LeBreton Library Parcel

Constructability Report

February 2023 | TYLin Ref. 10399

Dream Asset Management

PROJECT No.	10399
FIGURE No.	1-1

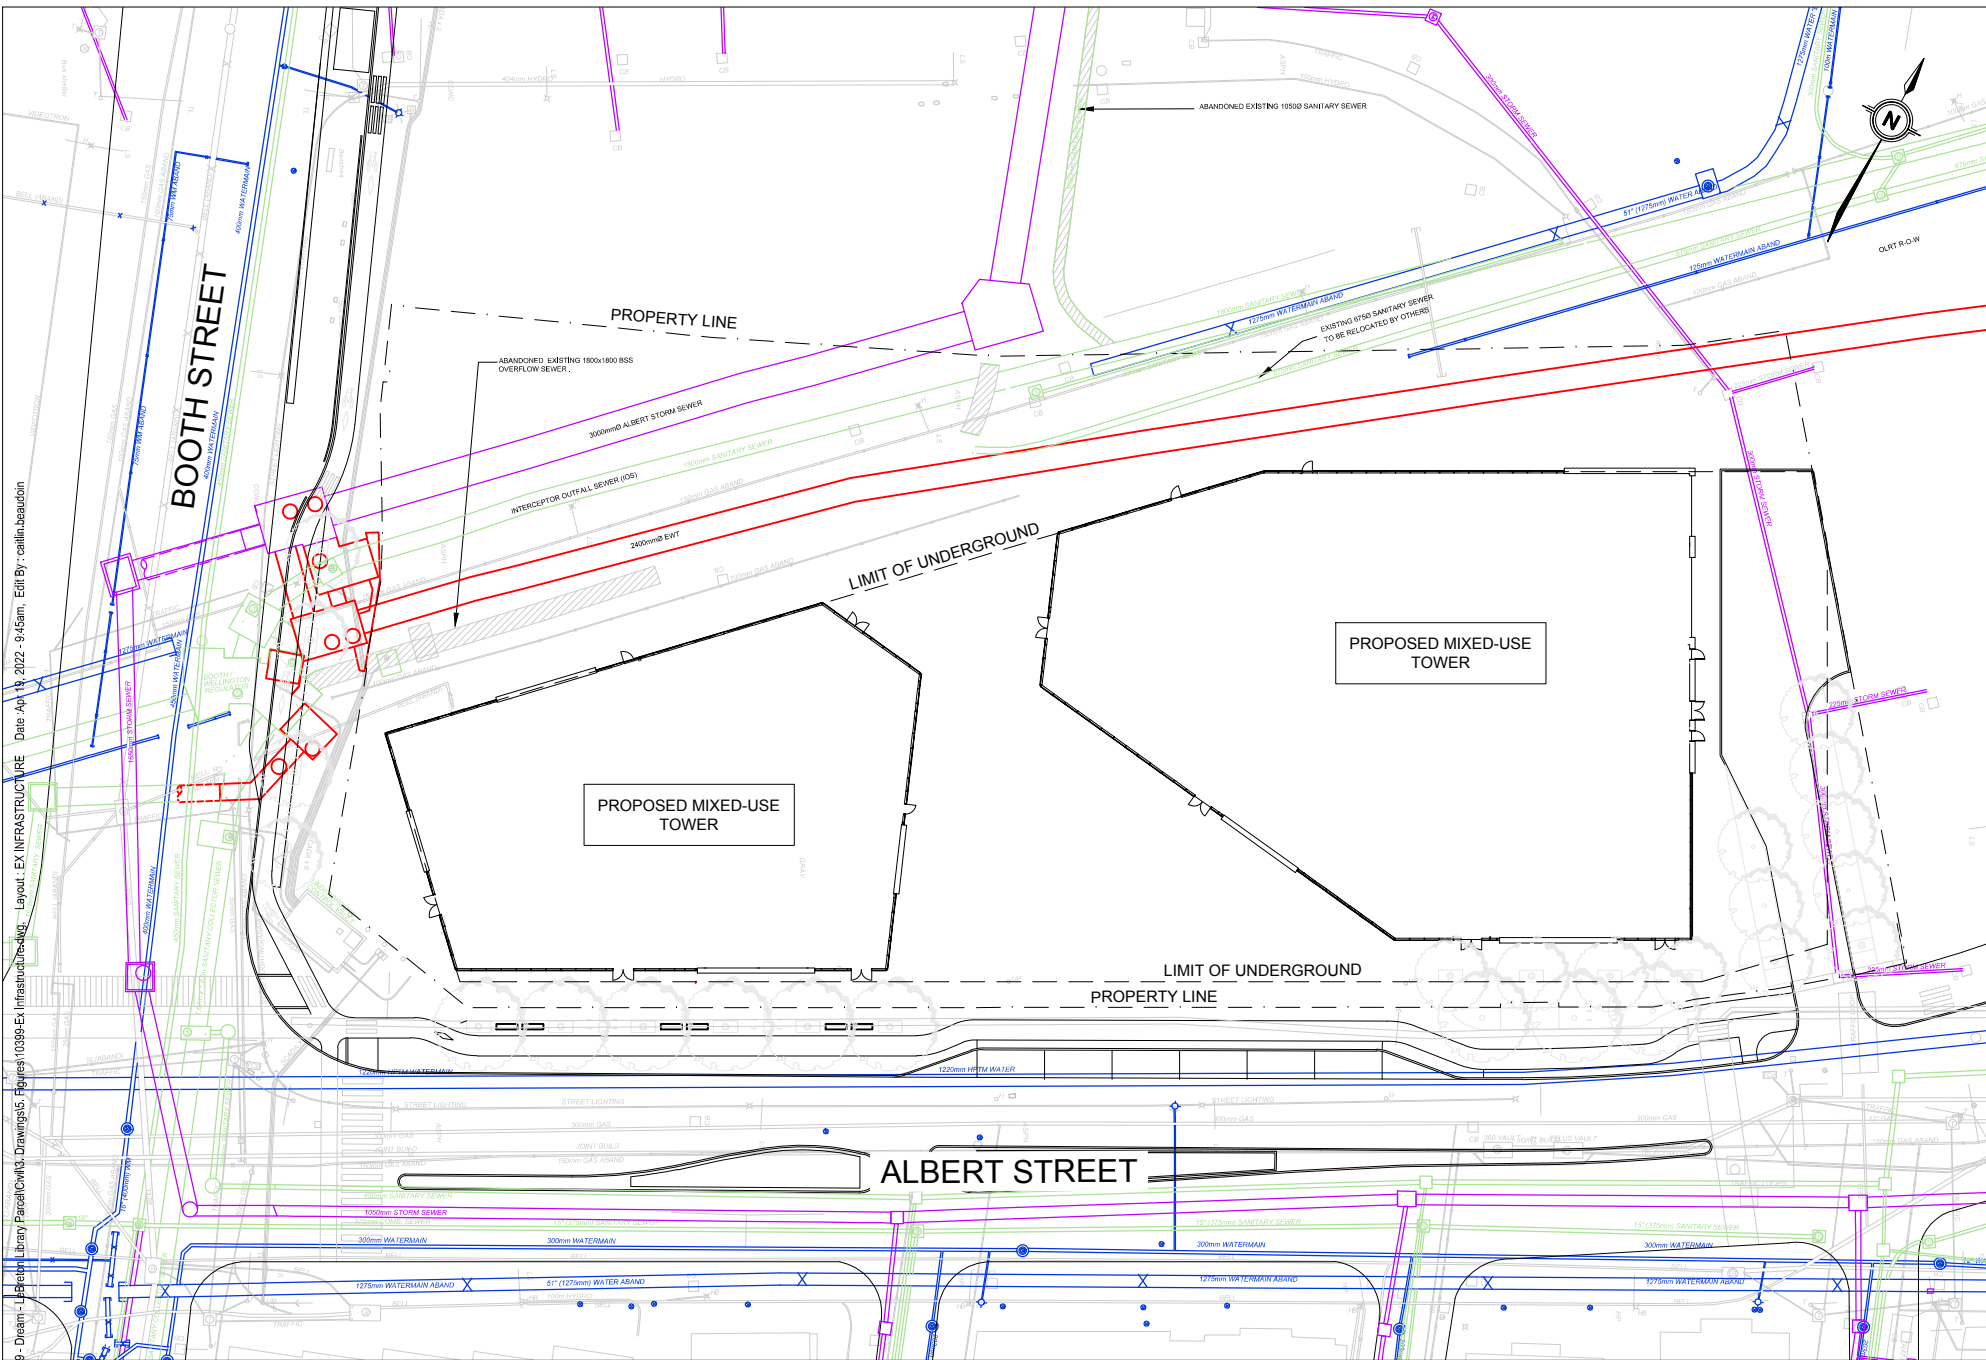
- a. The plans included within the constructability report (Figure 1-1) appears to show the existing Real Time Control (RTC) underground control vault at Booth/Albert and the associated underground ductbanks from this vault to the RTC facilities. It is unclear how/if the infrastructure is affected by the work, but this should be reviewed and addressed by the proponent. Excavations may extend into the footprint of the vault and the ductbanks, potentially requiring temporary support and protection.

- a. The plans included within the constructability report (Figure 1-1) appears to show the existing Real Time Control (RTC) underground control vault at Booth/Albert and the associated underground ductbanks from this vault to the RTC facilities. It is unclear how/if the

Figure 3-1 LLP-LOG-02 Extract

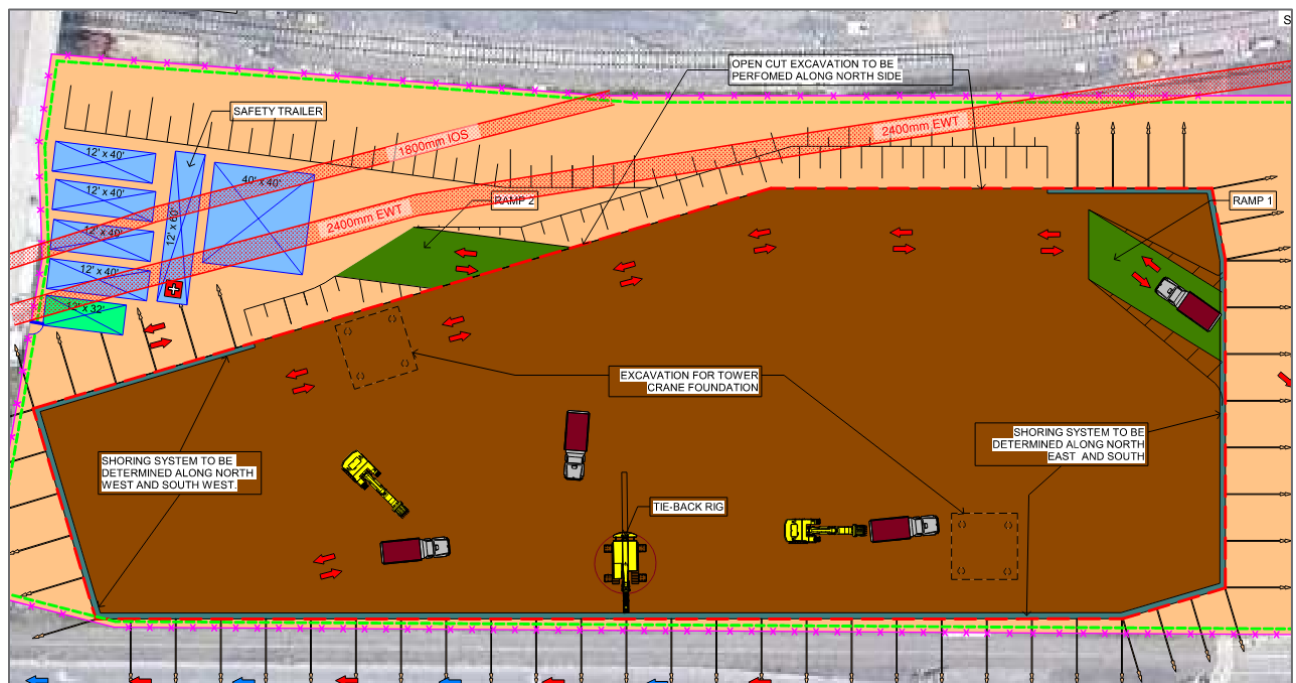
Revised report does not address comment fully. However, landscaping cross-sections illustrate that final grades for the MUP (lowest elevation area of site) will be at 56.0m at a minimum, consistent with the grades of the existing LRT tracks that are above-adjacent to the existing sewer infrastructure. It is assumed that the construction site overtop of the EWT and IOS will not be excavated lower than 56.0m outside of the shoring system (essentially existing grades). Provide confirmation whether any protective measures would be required to protect the sewers from construction activity/equipment.

In response to this comment, we note that no excavation lower than 56.0m is proposed over City infrastructure. As per the ED Logistics Plan Excavation Figure LLP-LOG-02 (**Appendix F**) and Marathon Shoring Plan (**Appendix E**), construction site grades in the northern portion of the site over existing City infrastructure will generally not vary significantly from the existing condition. As indicated in **Figure 3-1** (a marked-up extract of the Ellis Don Logistics Plan Grading Figure LLP-LOG-02 to show approximate alignment of EWT/IOS), City infrastructure lies outside of, or close to, the indicated top of slope linework. In localized areas some precut (to an elevation of 59.0m) will be necessary as part of excavation shoring (see Marathon Drg. MU4). On this basis, no additional protective measures are considered necessary.

Figure 1 - Example Cross Section Along North Foundation Wall

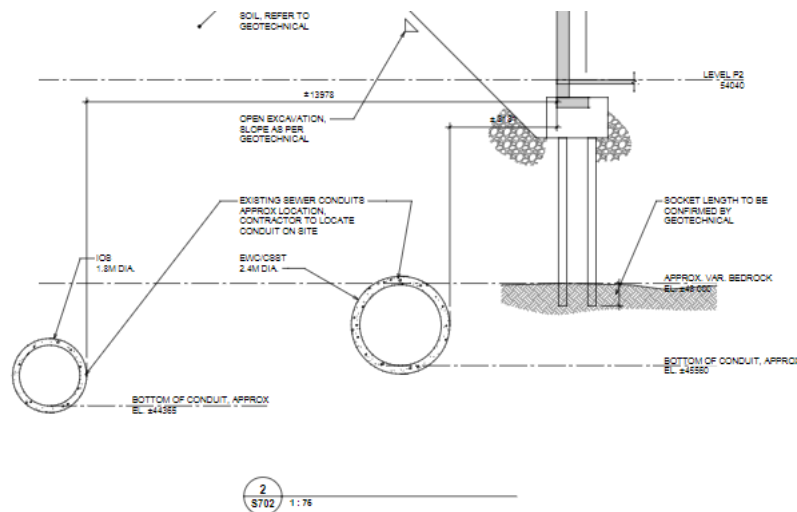
- f. The developer should provide drawings of proposed retaining wall along north side of site, and clarify its position relative to the EWT, IOS and Albert Storm Sewer and demonstrate that no additional loads will be imposed on the existing sewers.

- Comment 3a: Golder has reviewed the foundation drawings and confirms that there are no additional loads expected to be applied to the EWT by the proposed foundations.
- Comment 3b: The current RJC drawings indicate that the caisson foundations will have a diameter of 1.2 m and will have a rock socket depth of 3 to 4 m.
- Comment 3c: The statement is not included in the geotechnical report because the foundations were not designed at the time of preparing the report. We believe this statement in the constructability report refers to subsequent correspondence and discussion. Regardless, it is Golder's opinion that the currently proposed foundations should not impose any significant stress increase to the existing services in question and, notwithstanding the reference, the statement in the constructability report is generally valid.

- Comment 3d: The caissons are designed to have a rock socket depth of 3 to 4 m which is approximately 3 times the proposed diameter. This would typically be sufficient to be considered fixed (though the quality of the rock sockets does need to be confirmed during construction).

- Comment 3e: Given the discussion above, the increase in stress due to the permanent foundations is expected to be essentially zero.
- Comments 4a to 4e: These comments relate to shoring and temporary works which are designed by others. Golder would be pleased to provide additional review as required as these aspects of the project are designed in further detail.
